SERVICE BULLETIN

FUSELAGE - TAIL BOOM

Patches on the EC130 Fenestron / tail cone link

Corresponds to modification 074775

4.A.1. EDGE DISTANCE BETWEEN THE LATERAL PATCHES AND THE LOWER PATCH

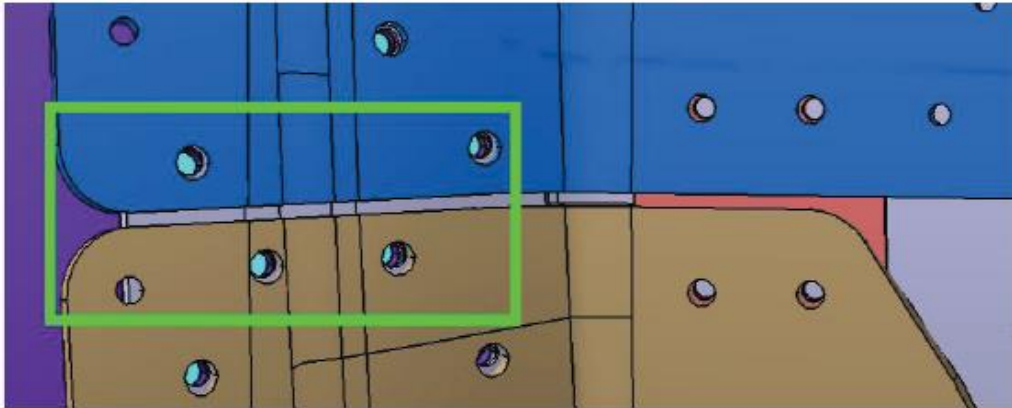
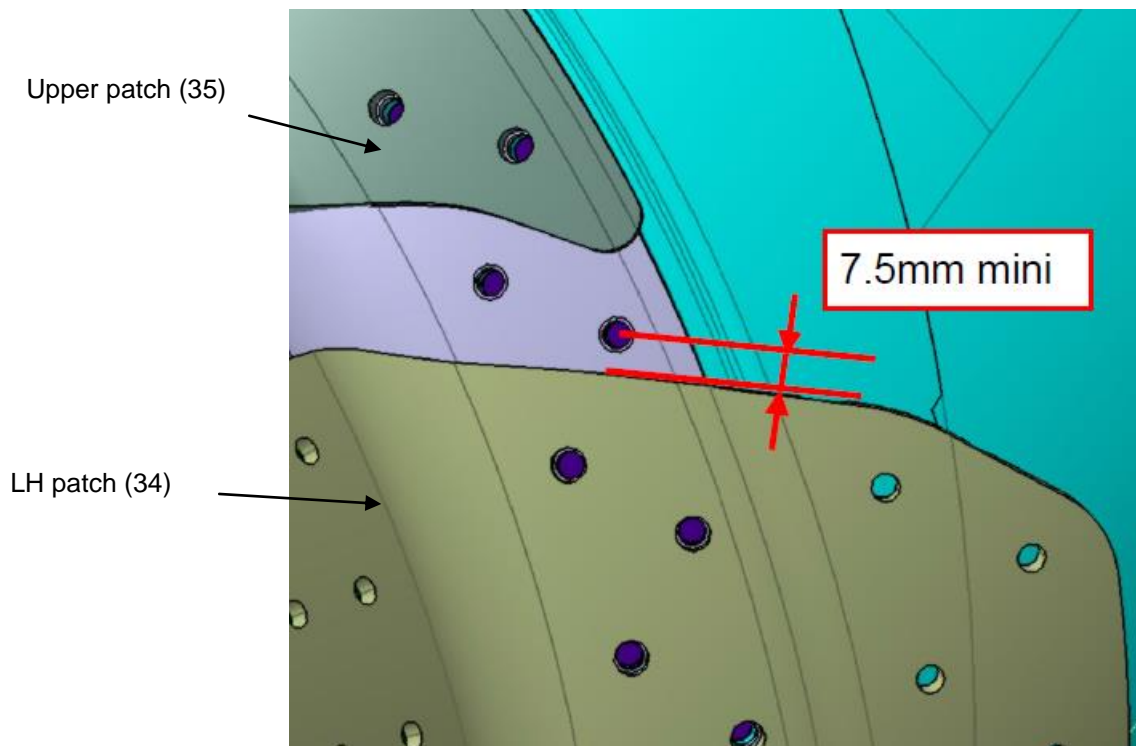
In the areas of juxtaposition of the lateral patches and the lower patch, the minimum distance between the holes and the edge is 5 mm.

- If the dimensions are not complied with, trim the patch(es) as per MTC Work Card 20-03-07-402 by complying with the edge distance criteria above.
- Protect the patch(es) with C26 (57) as per MTC Work Card 20-04-05-420.
